Rezoning Transportation Analysis

Petition Number: 2017-205

General Location Identifier: 14313108

| Date | Description |
|----------|---------------|
| 01-19-18 | First Review |

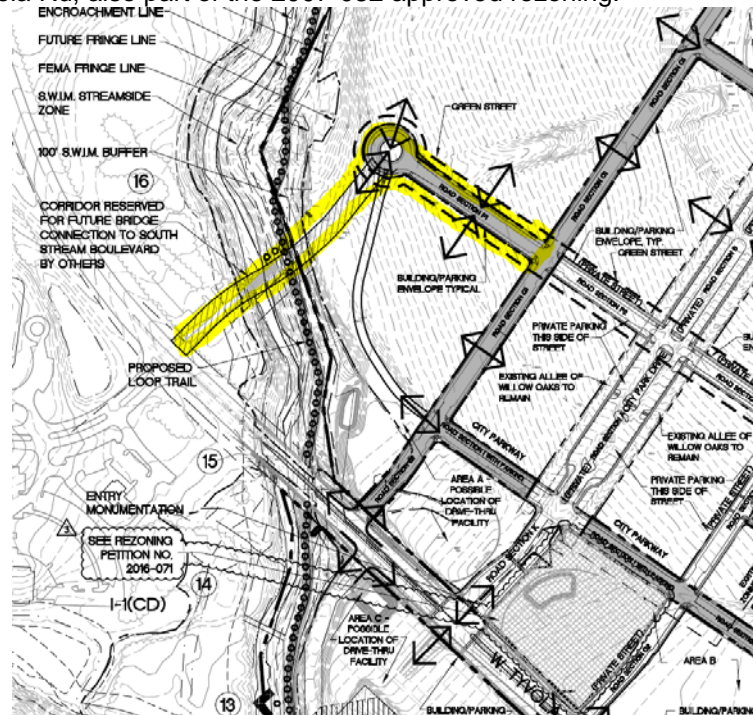
2. **Traffic Study** A Traffic Impact Study/Transportation Technical Memorandum may be needed for the complete review of this petition. CDOT is currently working with the Petitioner in evaluating the required traffic mitigations from Rezoning 2007-082 that have not been built yet and how the proposed rezoning petition affects them. CDOT will have further comments once more information is gathered.

After evaluating the changes proposed in this site plan amendment and the effect it has on existing and future transportation infrastructure, CDOT requests the petitioner revise the site plan to commit to the following before the next request for certificate of occupancy:

- a. the construction of Hive Dr connecting to City Park Dr and Millennium Av as part of the townhome development proposed in the site plan amendment.
 - b. dedication of right of way, fee simple, for the future connection of Speer Blvd to Billy Graham Pkwy, the realignment of Yorkmont Rd to connect to the future Speer Blvd and Price Ln as part of the townhome development proposed in the site plan amendment.
3. The petitioner should revise the site plan and conditional note(s) to show the street network connection approved in rezoning 2007-082 and the dedication of right of way for future bridge connection to Tyvola Rd, also part of the 2007-082 approved rezoning.
